<b>Delegated Report</b>		<b>Analysis sheet</b>		<b>Expiry Date:</b>	03/10/2024
		n/a		<b>Consultation Expiry Date:</b>	15/09/2024
<b>Officer</b>			<b>Application Numbers</b>		
Tony Young			1. 2024/3312/P 2. 2024/3452/A		
<b>Application Address</b>			<b>Drawing Numbers</b>		
Pavement outside of 27 Chalk Farm Road London NW1 8AG			Refer to draft decision notice		
<b>PO 3/4</b>	<b>Area Team Signature</b>	<b>C&amp;UD</b>	<b>Authorised Officer Signature</b>		
<b>Proposals</b>

1. <u>Planning application</u> - Installation of a Pulse Smart Hub with integrated digital screens and emergency functionality including provision of defibrillators. 2. <u>Advertisement consent application</u> - Display of illuminated content on digital screens integrated within new communication Hub.					
<b>Recommendations</b>		1. Refuse Planning Permission 2. Refuse Advertisement Consent			
<b>Application Types</b>		1. Full Planning Permission 2. Advertisement Consent

*Images 1 & 2 – proposed communications hub with integrated display screens*

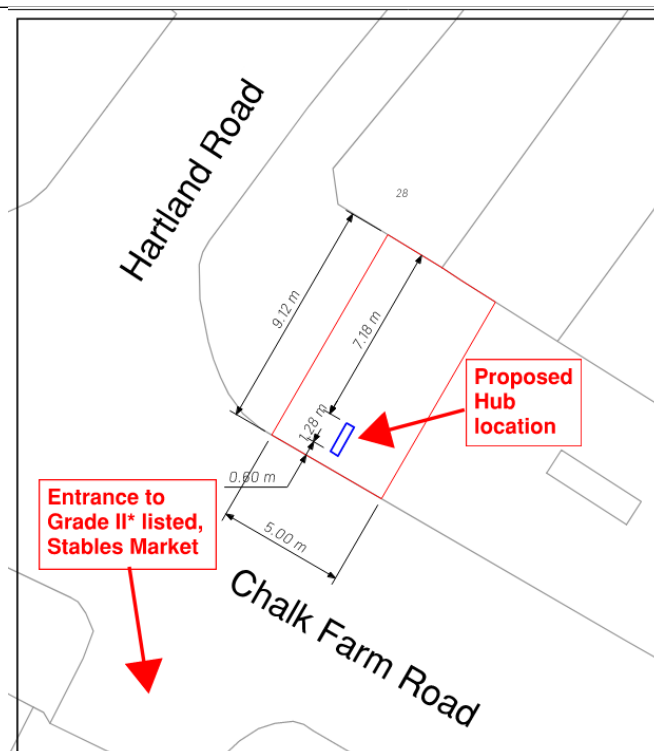
- 1.1 Planning permission and advertisement consent are sought for the installation of a free-standing Pulse Smart Hub with two integrated digital screens which display illuminated advertising content.
- 1.2 The proposed communication hub would principally comprise of double-sided display screens, made from dark grey anodised metal, black and clear laminated glass with a textured fiberglass coated finish. The structure would measure 2.54m high x 1.28m wide x 0.35m deep (see Images 1 and 2 below).

- 1.3 Two illuminated digital screens would be integrated into the proposed structure with advertisements displayed on both sides of the hub on its larger elevations. The display areas

would both measure 1.66m high x 0.93m wide with the bottom of each area being elevated 0.54m above pavement level.

*Image 5 – comparison of different communication kiosks/hubs (proposed hub structure in red)*

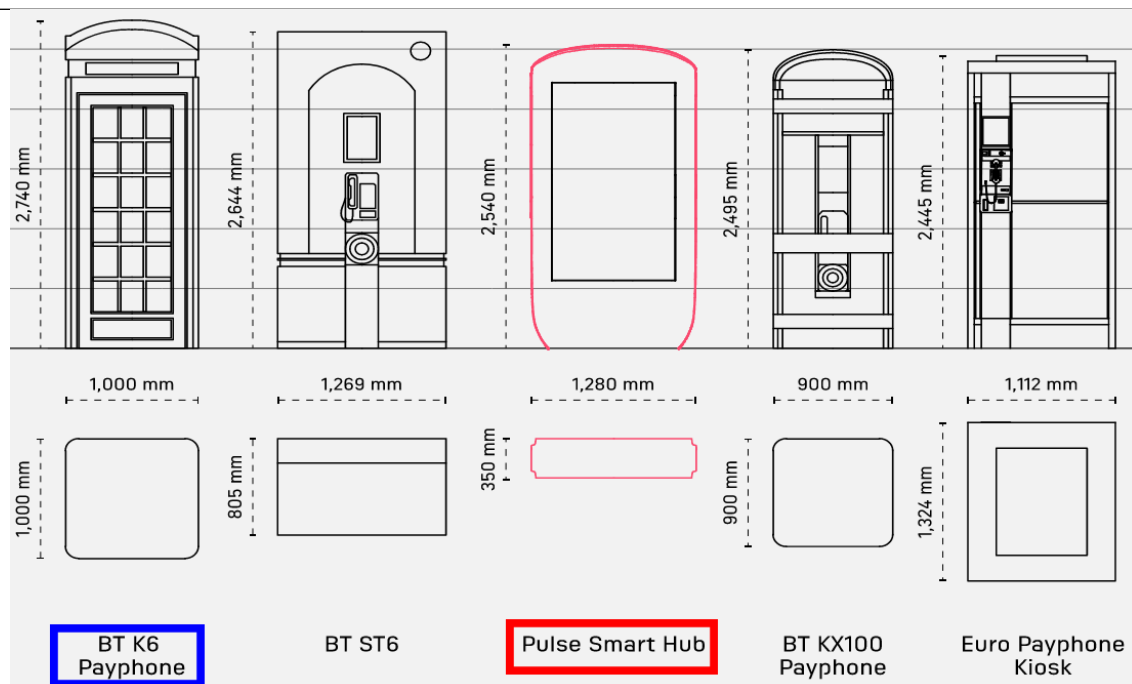
- 3.12 However, this has not been the case and the design approach has resulted in the creation of a large monolithic structure which gives the overall appearance as a large free-standing, advertisement panel rather than a structure for any other purpose.

- 3.13 The dark grey anodised metal, black and clear laminated glass with textured fiberglass would have a shiny finish and incongruous contemporary appearance within the streetscene. While the applicant's planning statement describes the design of the proposed hub as referencing a traditional red phone box, it is the Council's view that the proposed structure bears little relation. Indeed, a comparison of both a traditional red phone box and the current proposal as shown in the application submission not only shows a lack of similarity in design of them both, but also a substantially larger profile (see Image 5 below).

Image 6 – showing image of proposed hub structure in context with streetscene and entrance to Stables Market

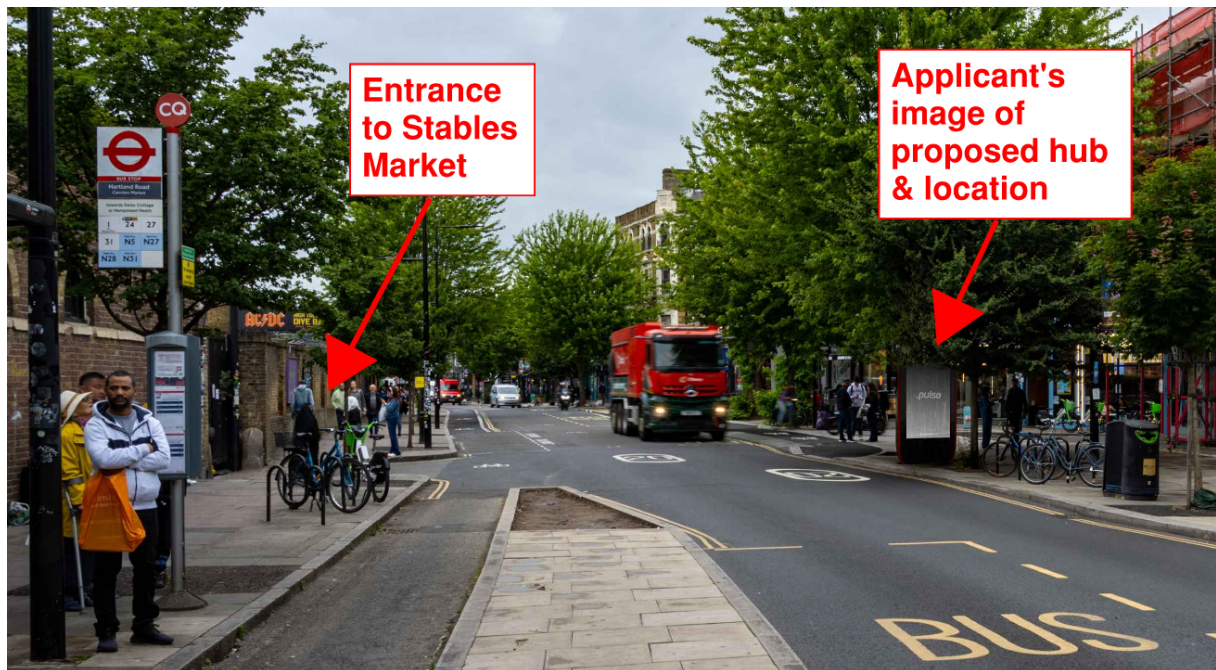
- 3.62 Guidance set out in the Camden's Streetscape Design Manual confirms that visibility splays or views at junctions must not be obstructed by street furniture. However, Image 6 below indicates how the proposed hub structure would obstruct visibility splays between pedestrians positioned on the south-east side of the unit and south-east bound drivers.

- 3.63 This would firstly be through the introduction of a physical and visual obstruction close to the kerbside edge for pedestrians attempting to cross Chalk Farm Road at this point to enter a principal entry point to Stables Market or use the bus-stop located across the road, by virtue of the location, size, solid appearance and orientation of the proposed hub structure itself. As a result, pedestrians would have increased difficulty in seeing any traffic approaching from the north-west along Chalk Farm Road. This could lead to dangerous situations involving pedestrians leaving the pavement at this point and oncoming road traffic, this being of particular concern for blind and partially sighted pedestrians, as well as, persons with mobility issues or with prams/push-chairs.

*Images 8 and 9 – showing proximity of application site to junction with Hartland Road and to cycle lane*

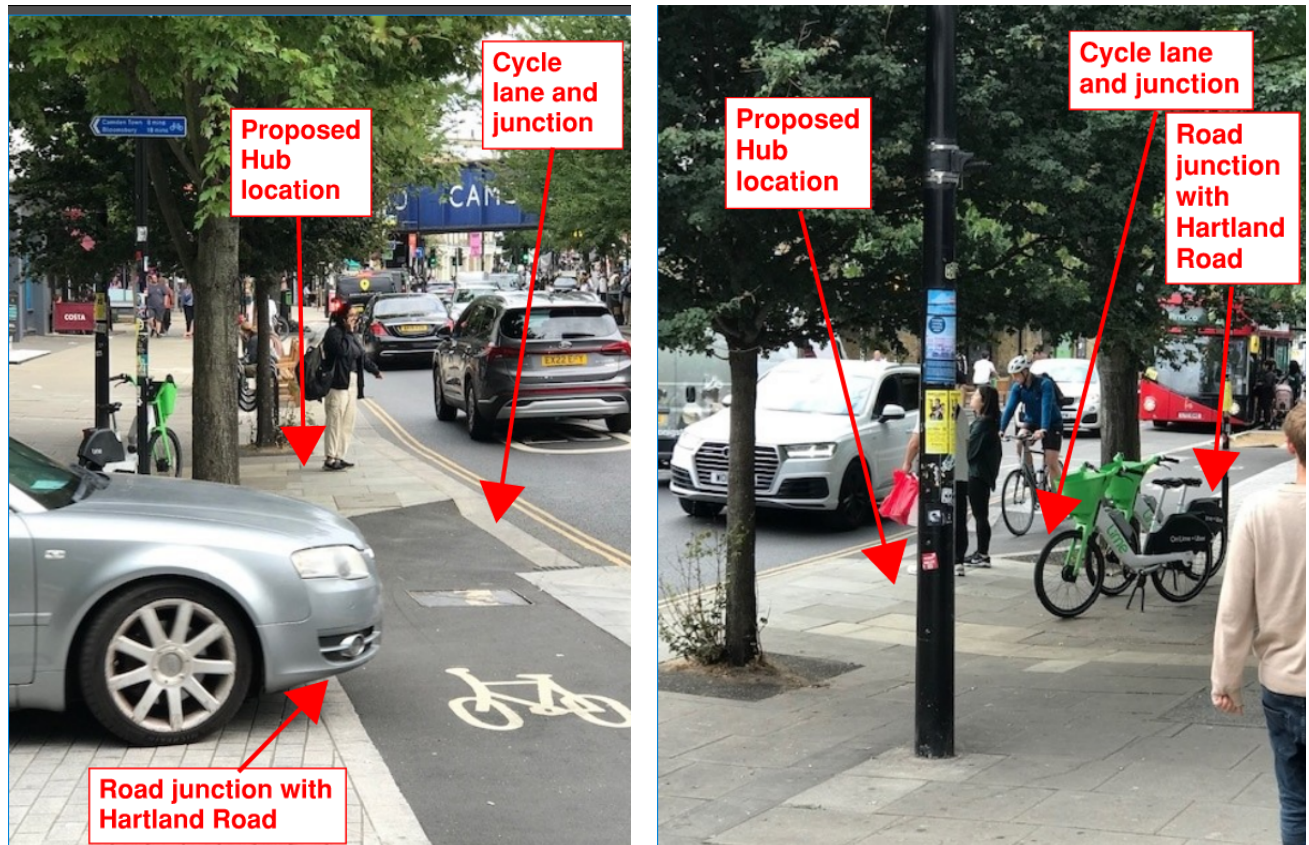
- 3.70 The nearness of the application site to the junction with Hartland Road raises serious highway safety concerns as the proposed hub structure would obstruct visibility splays along Chalk Farm Road. Having an illuminated digital screen in close proximity to this road junction and facing in a

north-westerly direction towards oncoming traffic, therefore, could also lead to driver and cyclist distraction (see Images 8 and 9 below).

- 3.71 As can also be seen from Images 8 and 9 above, both the road and cycle lane converge at this junction. A large illuminated advertisement screen proposed to face in a north-westerly direction towards oncoming road traffic and cyclists, therefore, would not only provide an immediate illuminated distraction to motorists and cyclists alike when attempting to join south-east bound traffic along Chalk Farm Road at this point (or indeed when attempting to turn into Hartland Road), but would also impair clear views given the size and orientation of the wider façade of the proposed hub structure on which the illuminated screen would be integrated.
